SUNDRY NOTICES AND REPORTS ON WELLS

8. Well Name and No. STREETCAR 15 FED 106H

EOG respectfully requests an amendment to our approved APD for this well to reflect the following changes:

Streetcar 15 Fed 207H (FKA 106H) API #: 30-025-47501

WELL LOCATION AND ACREAGE DEDICATION PLAT

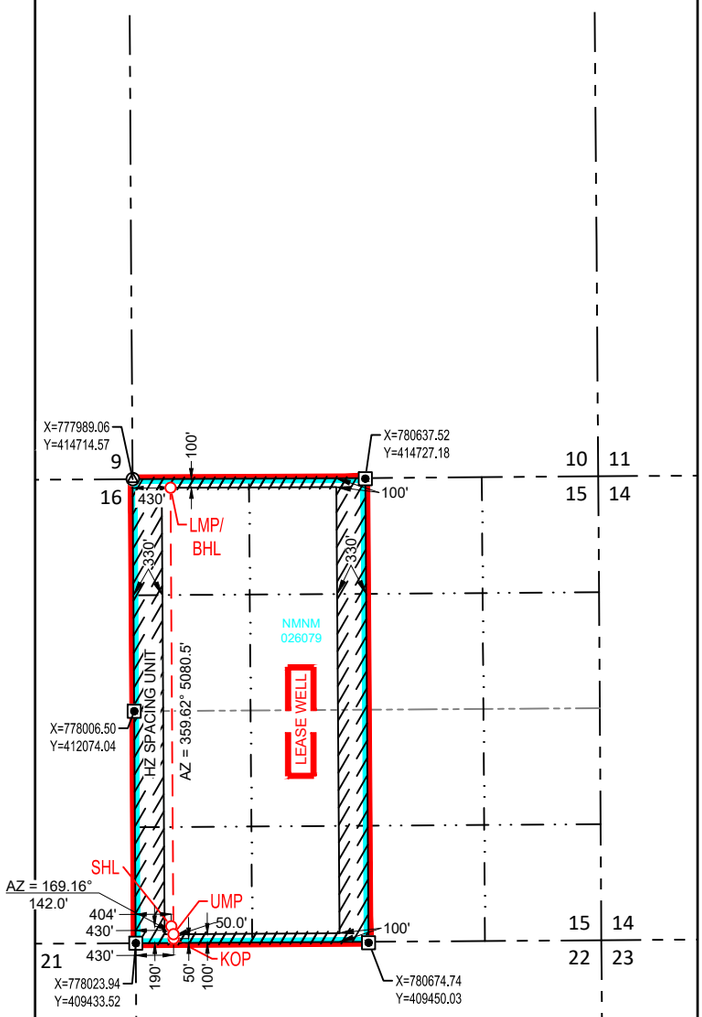
Change name from Streetcar 15 Fed 106H to Streetcar 15 Fed 207H.

Change BHL from T-25-S, R-33-E, Sec 15, 100' FNL, 330' FWL, Lea Co., NM,
to T-25-S, R-33-E, Sec 15, 100' FNL, 430' FWL, Lea Co., N.M.

UL or lot no.	Section	Township	Range	Lot Idn	Feet from the	North/South line	Feet from the	East/West line	County
D	15	25-S	33-E	-	100'	NORTH	430'	WEST	LEA

LOWER MOST PERF. (LMP)
BOTTOM HOLE LOCATION (BHL)
NEW MEXICO EAST
NAD 1983
X=778420 Y=414617
LAT.: N 32.1375424
LONG.: W 103.5673869
NAD 1927
X=737234 Y=414559
LAT.: N 32.1374179
LONG.: W 103.5669141
100' FNL 430' FWL

Revised Wellbore A:

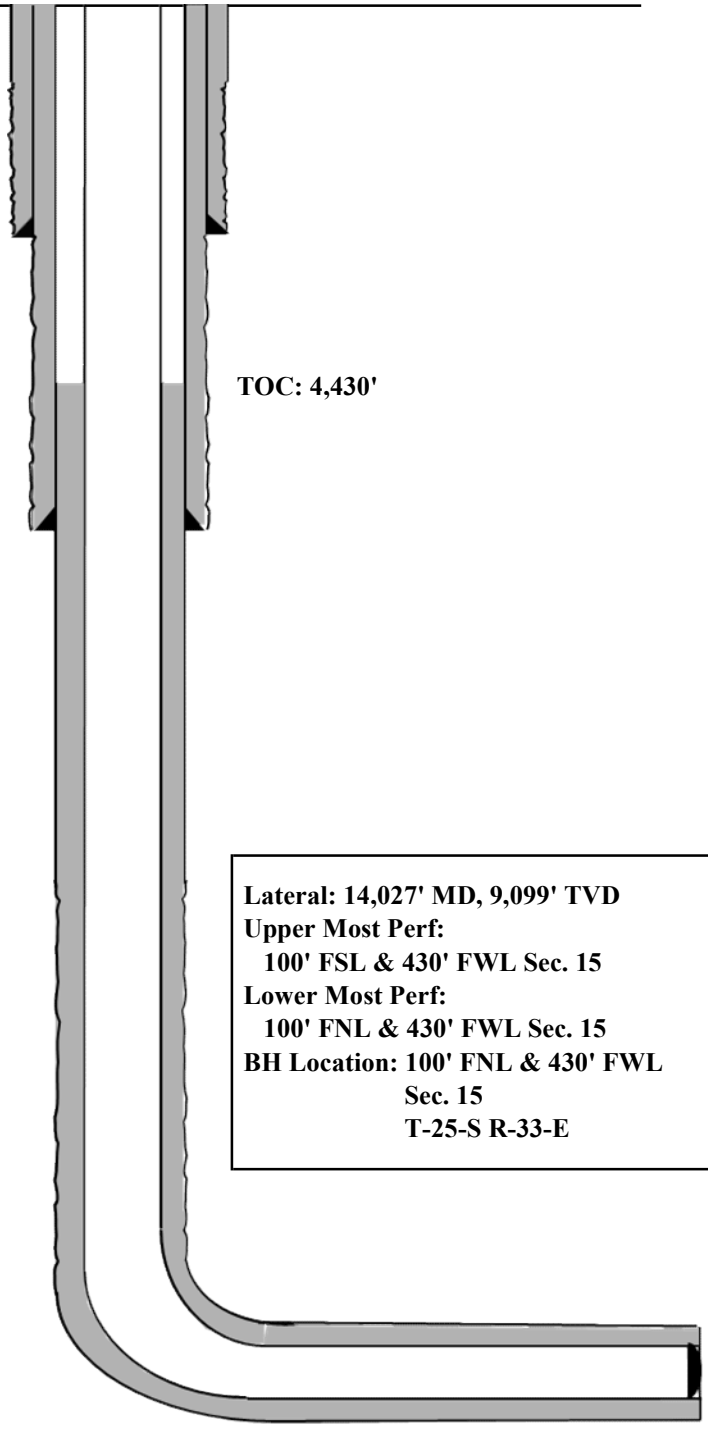
Update casing and cement program to current design.

Bit Size: 16"
13-3/8", 54.5#, J-55, STC
@ 0' - 1,270'

Bit Size: 11"
9-5/8", 40.#, J-55, LTC
@ 0' - 4,930'

Bit Size: 6-3/4"
5-1/2", 17.#, HCP-110, LTC
@ 0' - 14,027'

Lateral: 14,027' MD, 9,099' TVD
Upper Most Perf:
100' FSL & 430' FWL Sec. 15
Lower Most Perf:
100' FNL & 430' FWL Sec. 15
BH Location: 100' FNL & 430' FWL
Sec. 15
T-25-S R-33-E

Design A

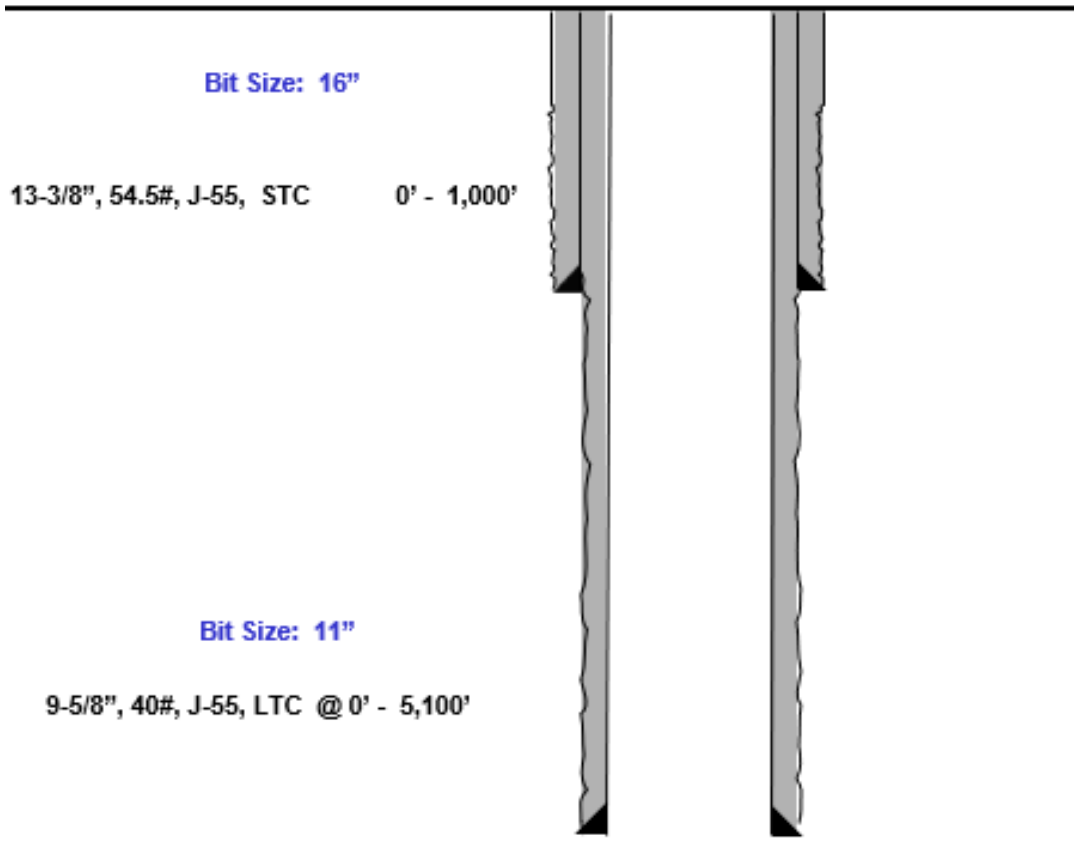
EOG requests permission to allow deviation from the 0.422'' annulus clearance requirement for the intermediate (salt) section from Onshore Order #2 under the following conditions:

2. The **9-5/8** inch intermediate casing shall be set at approximately **4,930** feet **TVD**. **CEMENT EXCESS < 25% CFO RECOMMENDATION. PLEASE REVIEW AND ENSURE CEMENT TO SURFACE.** The minimum required fill of cement behind the **9-5/8** inch intermediate casing is:

Proposed 11” Hole with 9.625” 40# J55/HCK55 LTC Casing

$= \frac{11.52 - 10.625}{2}$
- Previous Shoe – 13.375” 54.5# J55 STC
  - 0.995” Clearance to coupling OD (~1,200’ overlap)

Design B

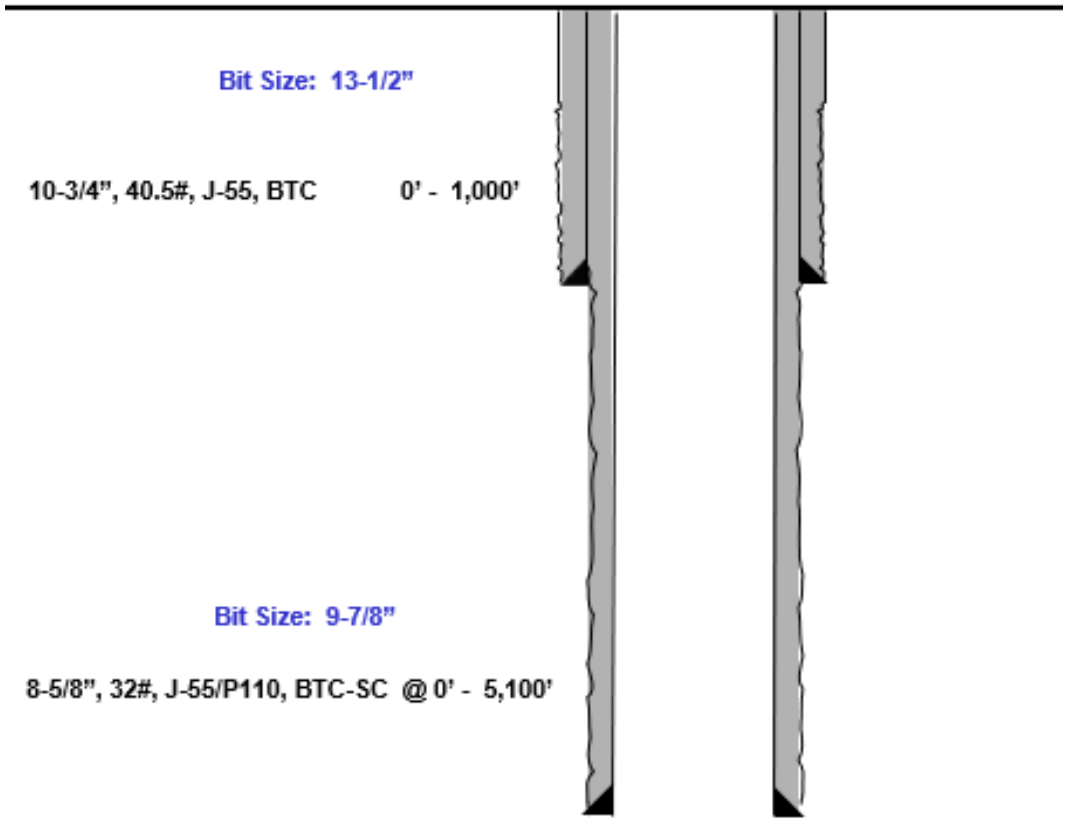
EOG requests permission to allow deviation from the 0.422'' annulus clearance requirement for the intermediate (salt) section from Onshore Order #2 under the following conditions:

Proposed 9.875” Hole with 8.625” 32# J55/P110 BTC-SC Casing

- 9.875” Bit + 0.42” Average hole enlargement = 10.295” Hole Size
  - 0.835” Clearance to casing OD
    $$= \frac{10.295 - 8.625}{2}$$
  - 0.585” Clearance to coupling OD
    $$= \frac{10.295 - 9.125}{2}$$
- Previous Shoe – 10.75” 40.5# J55 STC
  - 0.4625” Clearance to coupling OD (~1,200’ overlap)
    $$= \frac{10.05 - 9.125}{2}$$
